SERVICE BULLETIN RELEASE - 05/06/2014

01-001/14 - MULTI-MODEL - MASTER WARNING LIGHT IS ON AND INSTRUMENT CLUSTER WARNING MESSAGE IS DISPLAYED (DTC P1794 or DTC P1794 and P2502)

Subject: MASTER WARNING LIGHT IS ON AND INSTRUMENT CLUSTER WARNING MESSAGE IS DISPLAYED (DTC P1794 or DTC P1794 and P2502)	Bulletin No: 01-001/14
	Last Issued: 05/06/2014

APPLICABLE MODEL(S)/VINS

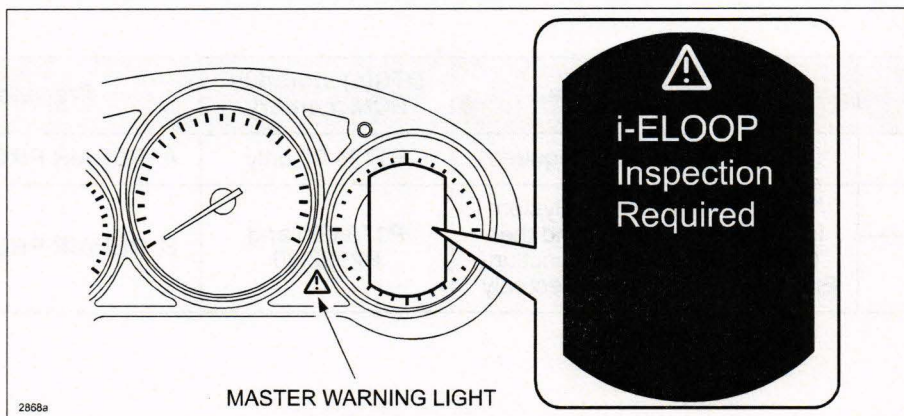
- This bulletin supersedes the previous bulletin 01-001/14, issued 02/25/2014, 01/24/2014, 01/10/2014 and 01-028/13, issued on 11/19/2013. The APPLICABLE MODEL(S)/VINS has been revised.
- Changes are noted below in Red beside the change bar.

- 2014 Mazda3 vehicles equipped with i-ELOOP and with VINs lower than JM1 BM ***** 162663 (produced before December 18, 2013)
- 2014-2015 Mazda6 vehicles equipped with i-ELOOP and with VINs lower than JM1 GJ ***** 162912 (produced before December 3, 2013)
